## STAFF RECOMMENDATION 2715 Brightwood Avenue September 21, 2016

**Application:** New construction—Infill  
**District:** Belmont-Hillsboro Neighborhood Conservation Zoning Overlay  
**Council District:** 18  
**Map and Parcel Number:** 11704042000  
**Applicant:** Stone Oak Builders  
**Project Lead:** Melissa Baldock, melissa.baldock@nashville.gov

<p><b>Description of Project:</b> Application is to construct infill on a vacant lot.</p> <p><b>Recommendation Summary:</b> Staff recommends approval of the infill with the following conditions:</p> <ol style="list-style-type: none"><li>1. The finished floor height be consistent with the finished floor heights of the adjacent historic houses, to be verified by MHZC staff in the field;</li><li>2. Staff approve the final details, dimensions and materials of windows and doors prior to purchase and installation;</li><li>3. Staff approve masonry;</li><li>4. Staff approve the roof color;</li><li>5. A front walkway be added leading from the sidewalk to the front entry, and staff approve the walkway material;</li><li>6. All multiple window openings have a four to six inch (4"-6") mullion in between them; and</li><li>7. The HVAC shall be loca

Figure 1. The lot at 2715 Brightwood Avenue

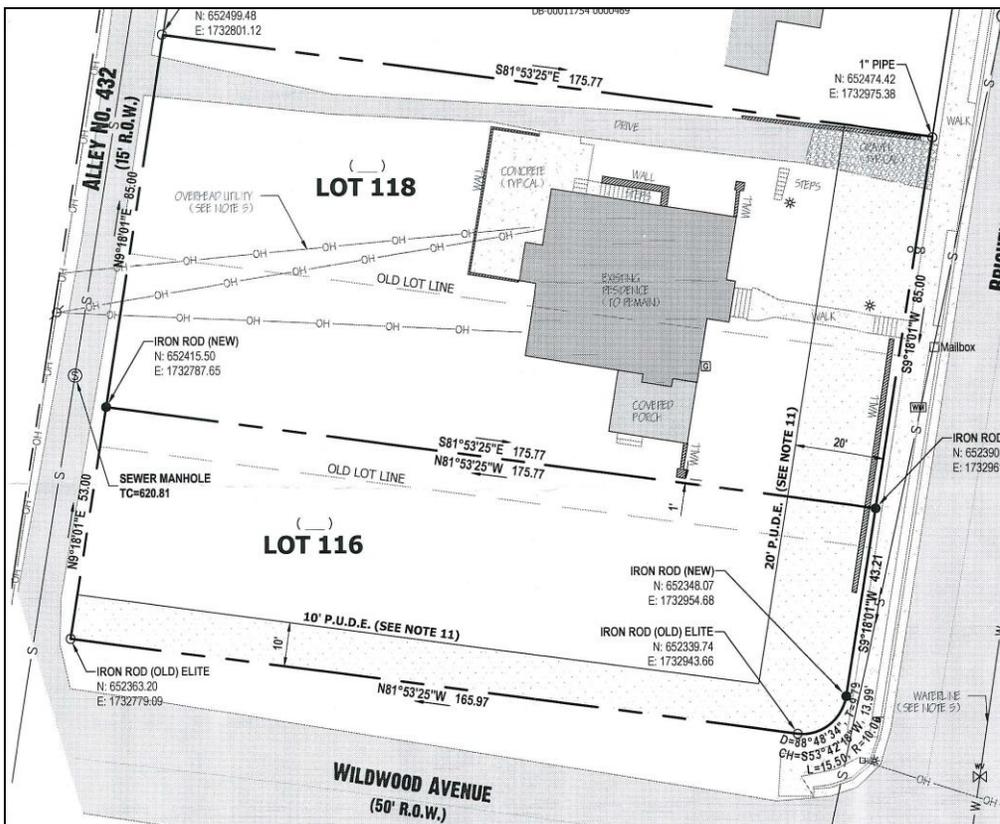
**Background:** 2715 Brightwood Avenue is a vacant lot that was recently subdivided from the lot at 2711 Brightwood Avenue (Figures 1 & 2).

FRONT ELEVATION

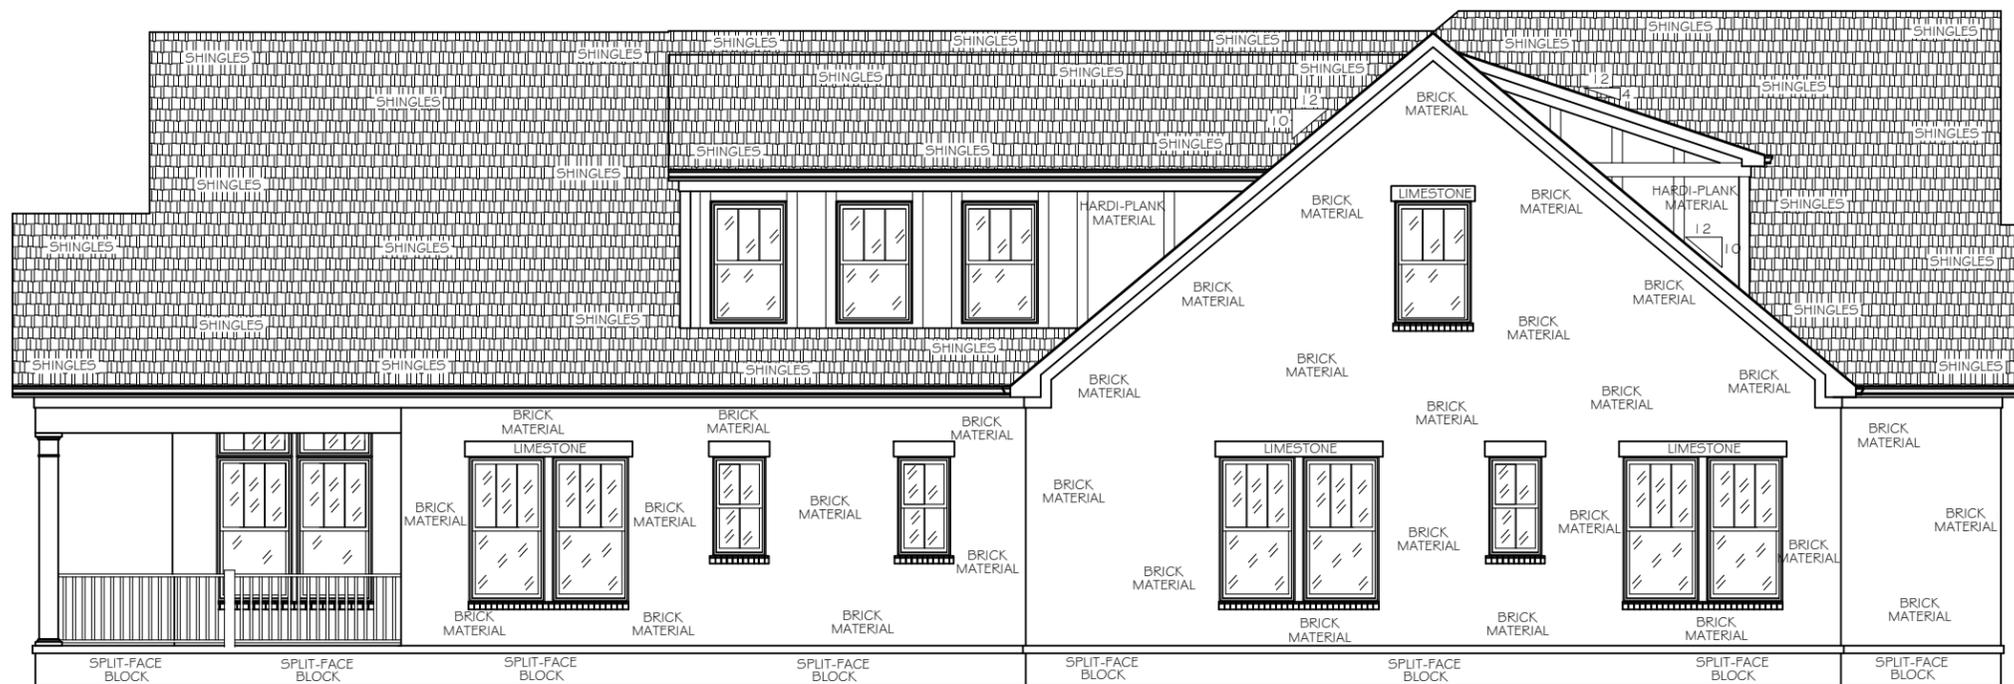
Roof form: The primary roof form will be a cross gable. The front gable will have a slope of 14/12 and the side gable will have a slope of 10/12. The front façade will have a shed dormer that is setback four feet (4') from the wall below and has a slope of 4/12. The shed dormer connects to the cross gable, which staff finds to be appropriate. At the back of the gable, the rear section of the house ties into the back slope. On the left elevation, which faces Wildwood Avenue, the rear portion is inset two feet (2') and has shed dormers that are inset another two feet (2'). The dormers on the right elevation are also shed dormers that are inset two feet (2') from the wall below. Staff finds that the proposed roof forms are compatible with the historic neighborhood and meet Section II.B.1.e. of the design guidelines.

Proportion and Rhythm of Openings: The infill's primary windows are twice as tall as they are wide, thereby meeting the historic proportions of openings. There are no large expanses of wall space without a window or door opening. Some openings with three to five window openings do not have a four to six inch (4"-6") mullion in between them, and staff asks that all window openings with more than one opening have a four to six inch (4"-6") mullion in between them. With this condition, staff finds the infill's proportion and rhythm of openings to meet Section II.B.1.g. of the design guidelines.

1. The finished floor height be consistent with the finished floor heights of the adjacent historic houses, to be verified by MHZC staff in the field;
2. Staff approve the final details, dimensions and materials of windows and doors prior to purchase and installation;
3. Staff approve masonry;
4. Staff approve the roof color;
5. A front walkway be added leading from the sidewalk to the front entry, and staff approve the walkway material;
6. All multiple window openings have a four to six inch (4"-6") mullion in between them; and
7. The HVAC shall be located behind the house or on either side, beyond the mid-point of the house.

LEFT ELEVATION

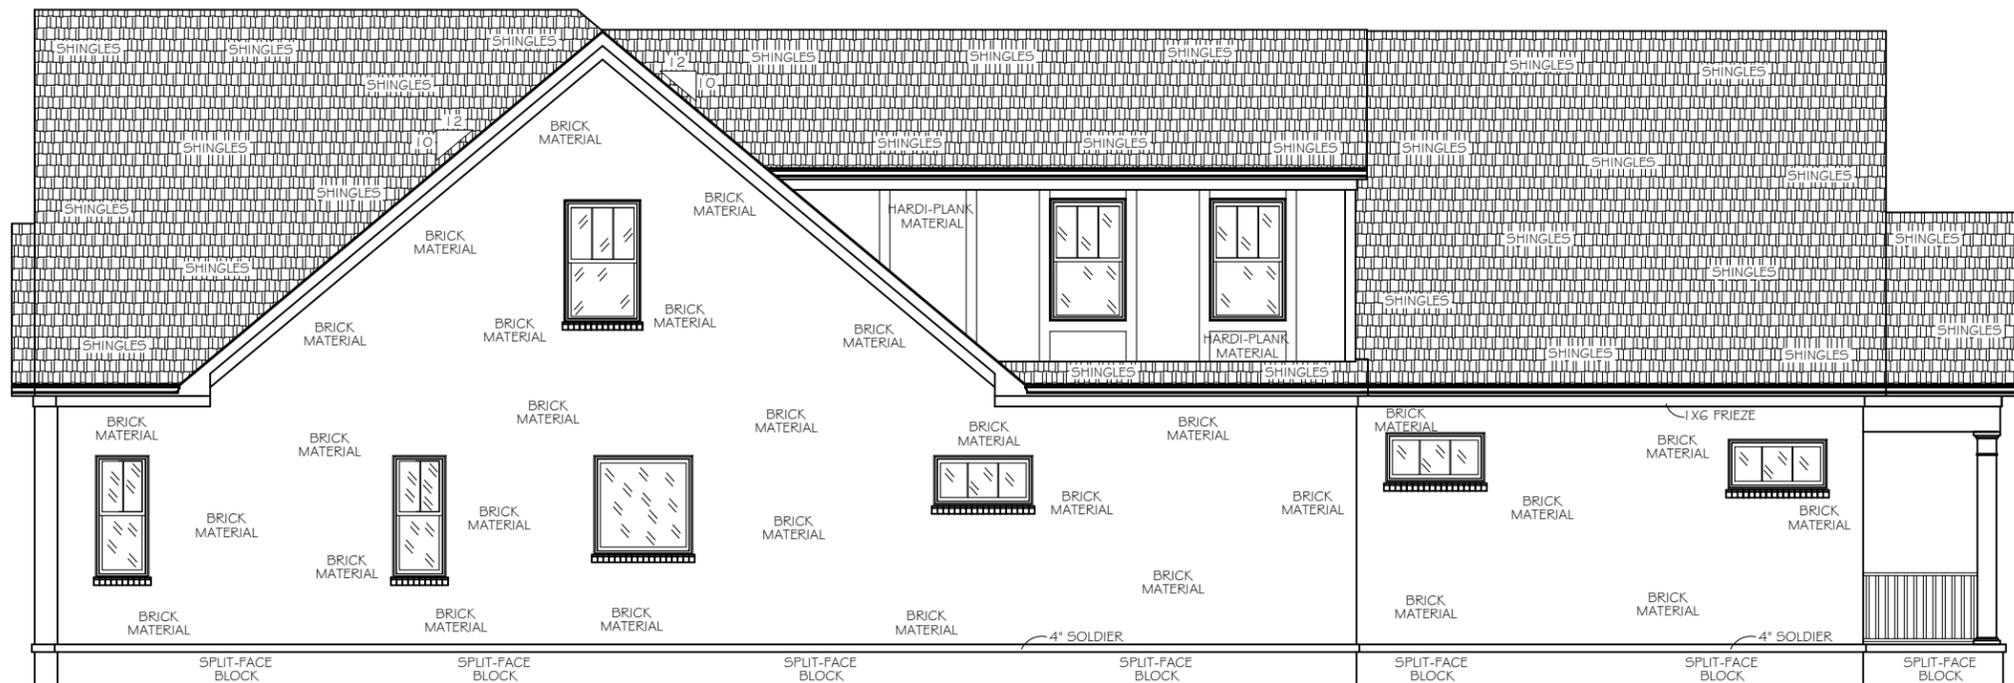
Height & Scale: The proposed infill will be one and a half stories with a maximum height of twenty-nine feet, six inches (29'6"). However, the bulk of the house will be twenty-eight, six inches (28'6") tall. The height is in keeping with the historic context, where the historic houses are one and one-and-a-half stories with heights ranging from twenty-three to twenty-nine (23'-29').

FIRST FLOOR PLAN

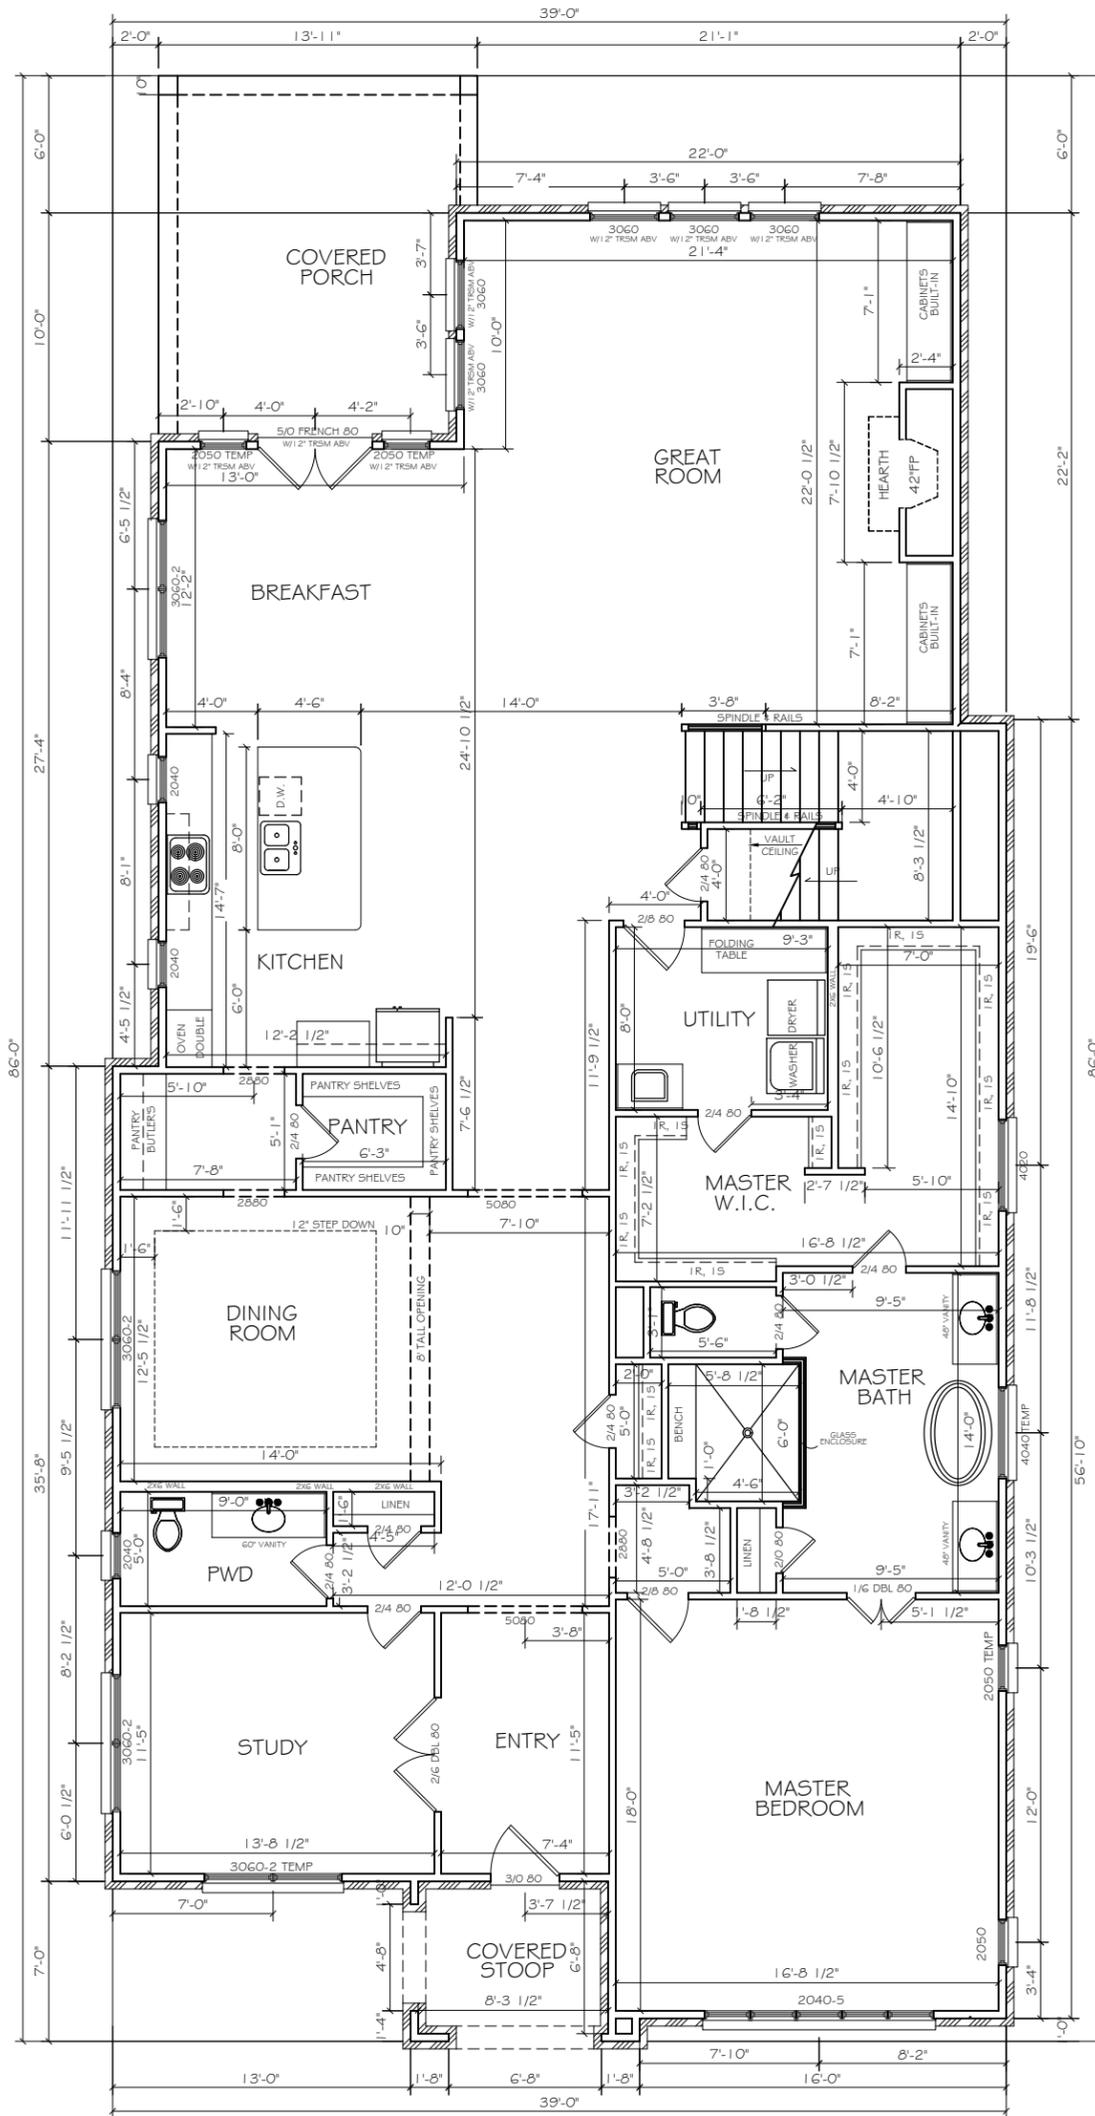
Orientation: The site is located at the corner of Brightwood Avenue and Wildwood Avenue. The house is oriented towards Brightwood, which is appropriate. There is a front entrance behind a stoop that is six feet, eight inches (6'8") deep. The site plan did not include a front walkway, and staff recommends the inclusion of a front walkway leading from the sidewalk to the front stoop. Vehicular access to the site will be via the rear alley. Staff finds that the infill's orientation meets Section II.B.1.f. of the design guidelines.

Appurtenances & Utilities: The location of the HVAC and other utilities was also not noted. Staff asks that the HVAC be located on the rear façade, or on a side façade beyond the midpoint of the house. No other new appurtenances were indicated on the plans.
